SERVICE BULLETIN

CHECKING OR REPLACEMENT

OF FLEXIBLE FUEL LINE

SB-912-054

Fig. 1

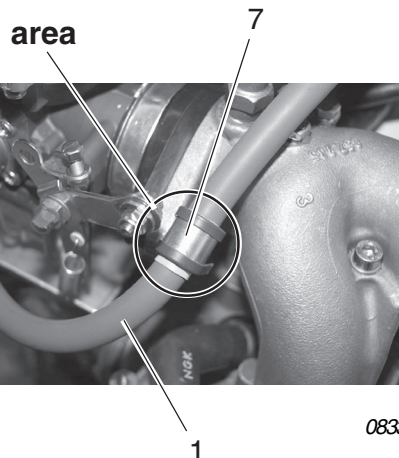
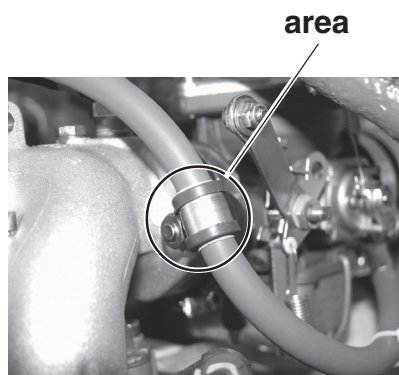
Visual inspection of the fuel line (1) in the area clamp (7) and both ends of the yellow protection cover. (see Fig. 1)

◆ **NOTE:** A possible crack can be observed by careful bending of the fuel line. If you notice cracks or porosity then you need to replace the fuel line in accordance section 3.1.2.

2. Install both cable clamp (7) in accordance with Fig.1 on the fuel line.

Fig. 2
08184

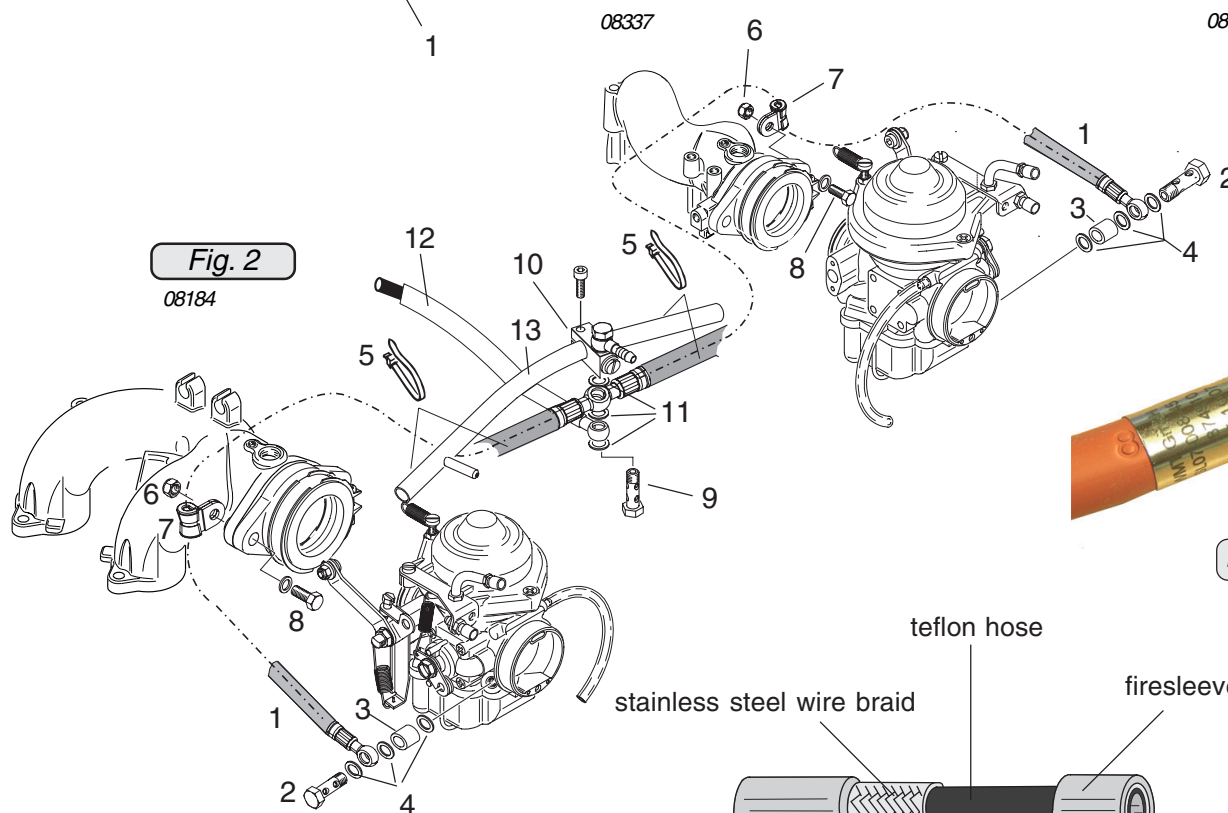
1. Unscrew the banjo bolt (2) with distance sleeve (3) and 3 gasket rings (4).

2. Cut the cable tie (5).

3. Remove hex. nuts M8 (6) together with clamp (7). Held in place by hex. screw (8).

4. Remove banjo bolt (9) from clamp block (10) together with 3 gasket rings (11).

◆ **NOTE:** The gasket rings 8x13 (4), used on the banjo bolt of the carburetor, are of different thickness compared to the gasket rings (11), used on the banjo bolt of the clamp block.

5. Remove the fuel line (12).

1. Install flexible fuel line (1 and 12) and the banjo bolt (9) with new sealing ring (11) on the clamp block (10). Tightening torque of banjo bolt (9) 10 Nm (90 in.lb). Check that the fuel lines are not under strain or tension.

3. Install the fuel line (1) with distance sleeve (3) and sealing ring (4) on the carburetors. Tightening torque of banjo bolt (2) 10 Nm (90 in.lb). Place cable clamp (7) into position.

4. For proper support. Install the clamp (7) and hex. nut M8 (6) with LOCTITE 221. Tightening torque of hex. nut (6) 15 Nm (133 in.lb).
